SURRY POWER STATION, UNIT NO. 1

AMENDMENT TO FACILITY OPERATING LICENSE

Amendment No. 49
License No. DPR-32

ATTACHMENT TO LICENSE AMENDMENT NOS. 49 AND 48
FACILITY OPERATING LICENSE NOS. DPR-32 AND DPR-37
DOCKET NOS. 50-280 AND 50-281

HOT CHANNEL FACTOR NORMALIZED

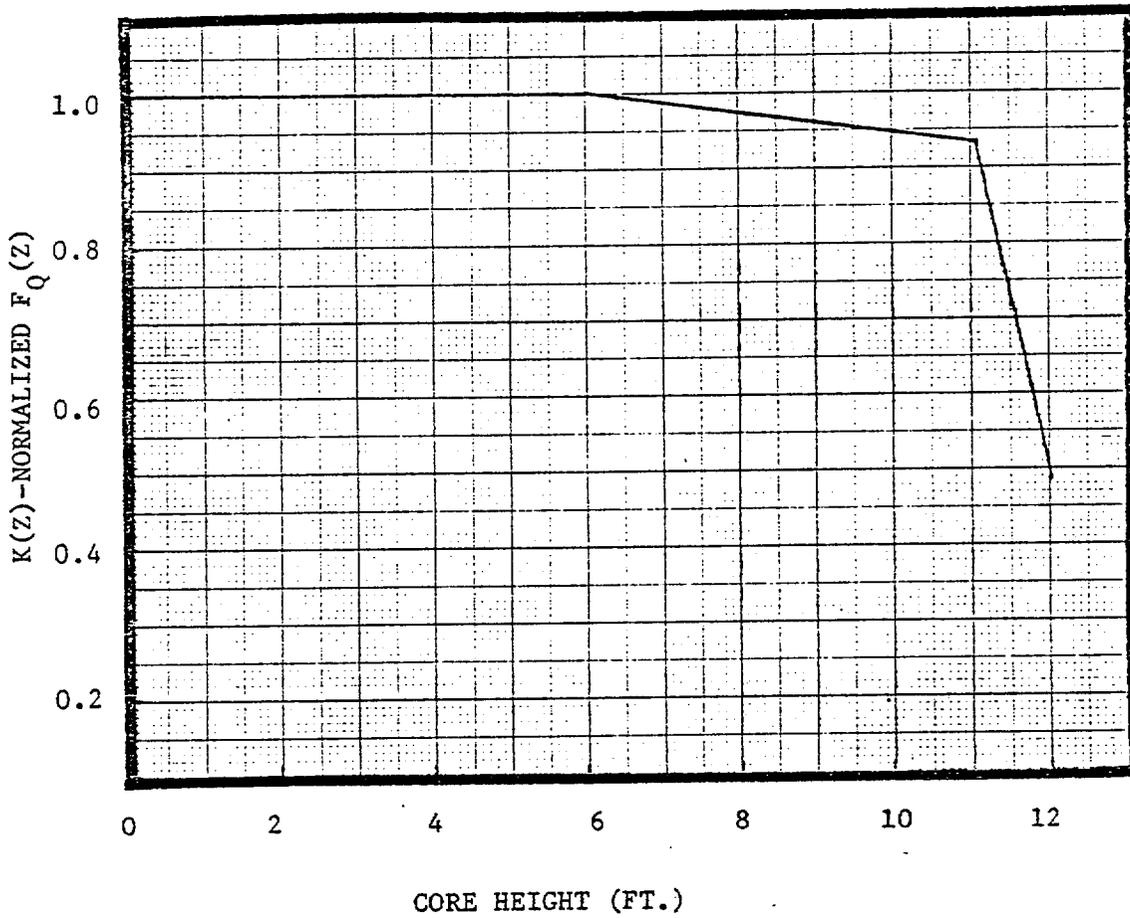
where P is the fraction of rated power at which the core is operating, K(Z) is the function given in TS Figure 3.12-8, Z is the core height location of F_Q, and T(BU) is the interim thimble cell rod bow penalty on F_{ΔH}^N given in TS Figure 3.12-9.

It should be noted that the enthalpy rise factors are based on integrals and are used as such in the DNB and LOCA calculations. Local heat fluxes are obtained by using hot channel and adjacent channel explicit power shapes which take into account variations in radial (x-y) power shapes throughout the core. Thus the radial power shape at the point of maximum heat flux is not necessarily directly related to the enthalpy rise factors. The results of the loss of coolant accident analyses are conservative with respect to the ECCS acceptance criteria as specified in 10 CFR 50.46 using an upper bound envelope of 2.05 times the hot channel factor normalized operating envelope given by TS Figure 3.12-8.

$$F_Q(Z) \leq 2.05/P \times K(Z) \text{ for } P > .5$$

$$F_Q(Z) \leq 4.10 \times K(Z) \text{ for } P \leq .5$$

AXIAL FLUX DIFFERENCE LIMITS
AS A FUNCTION OF RATED POWER

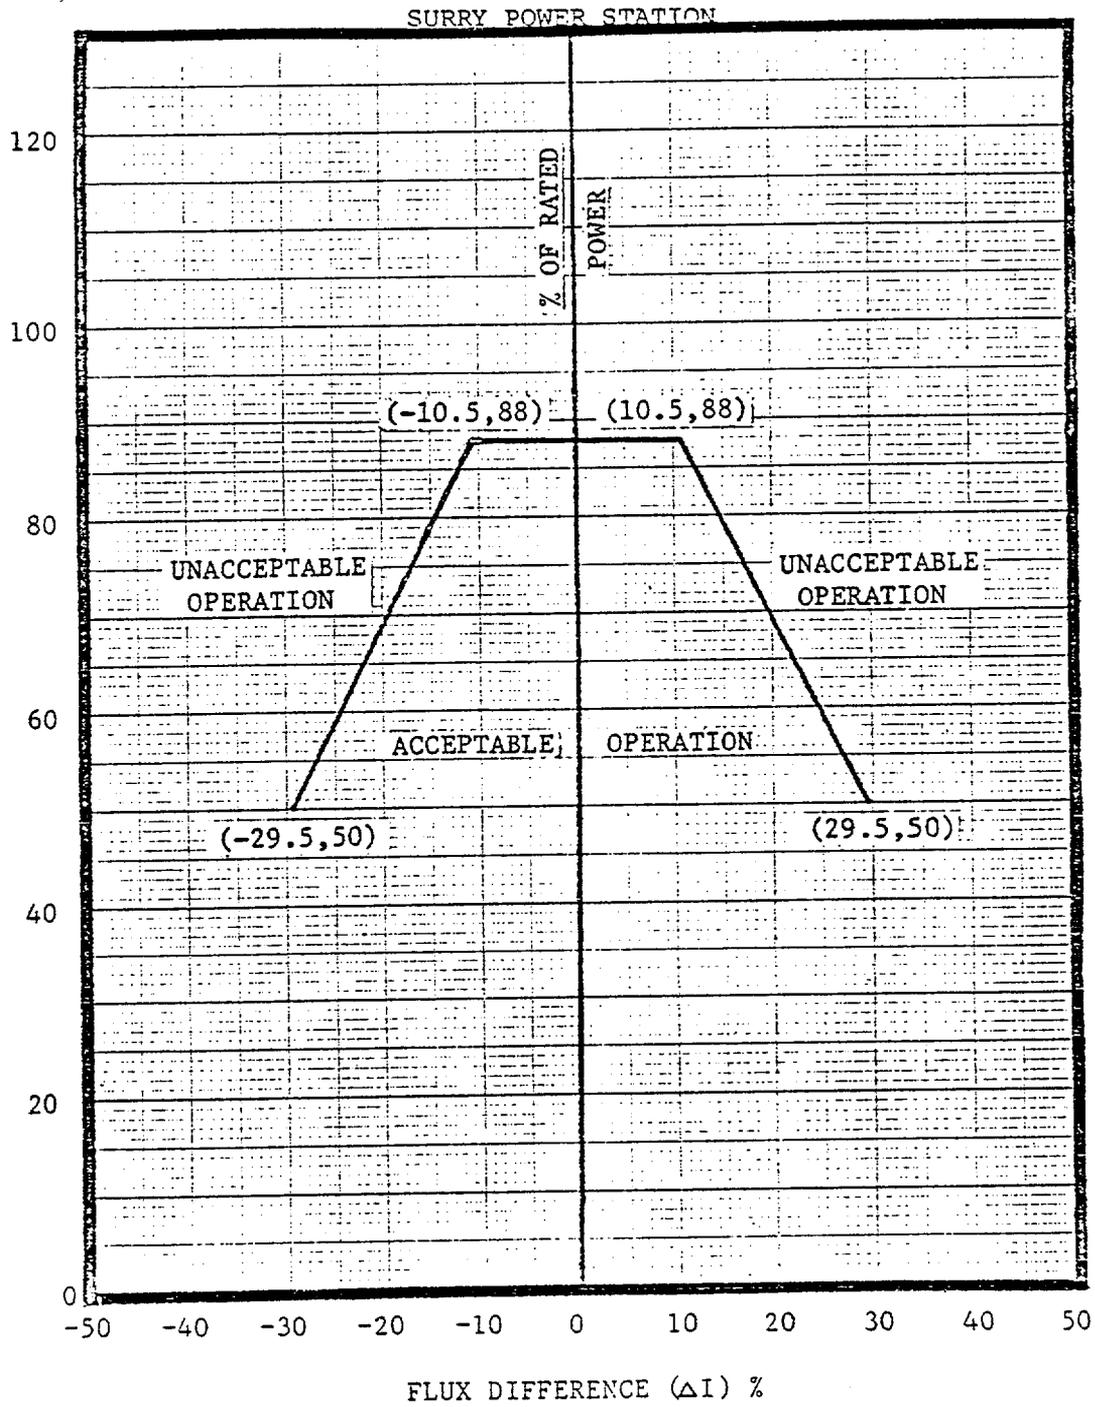
- (3) New limits for the axial flux difference. This proposed change would specify the new limits for the allowable axial flux difference by: (a) assigning lower value (88%) for the reactor power level above which the axial flux difference must be maintained within a $\pm 5\%$ target band; (b) defining the operational conditions for which axial flux difference could remain outside the prescribed limits without reduction of reactor power, and (c) specifying new allowable axial flux difference limits for reactor operation below 88% of its rated power.

With the exception of the new allowable axial flux difference limits, all the changes listed above would make the Technical Specifications more restrictive. The last change extends the allowable axial flux difference limits and results from a plant specific analysis (Reference 2) performed by the licensee to justify this change. The current allowable axial flux difference limits were derived by a Westinghouse generic analysis which resulted in limits more restrictive than the proposed limits resulting from the analysis performed specifically for Surry Units 1 and 2. The proposed limits are based on plant specific parameters and are conservative. The proposed limits, derived by previously approved methods, assure that the power distribution in the core will be maintained within specific bounds (F_0 , $F_{\Delta H}$) and all safety limits and criteria will be met. We conclude that because this change does not involve a significant increase in the probability or consequences of accidents previously considered and does not involve a significant decrease in a safety margin, it does not involve a significant hazards consideration.

- b. At a power level no greater than 88 percent of rated power,
 - (1) The indicated axial flux difference may deviate from its target band for a maximum of one hour (cumulative) in any 24-hour period provided the flux difference is within the limits shown on Figure 3.12-10.
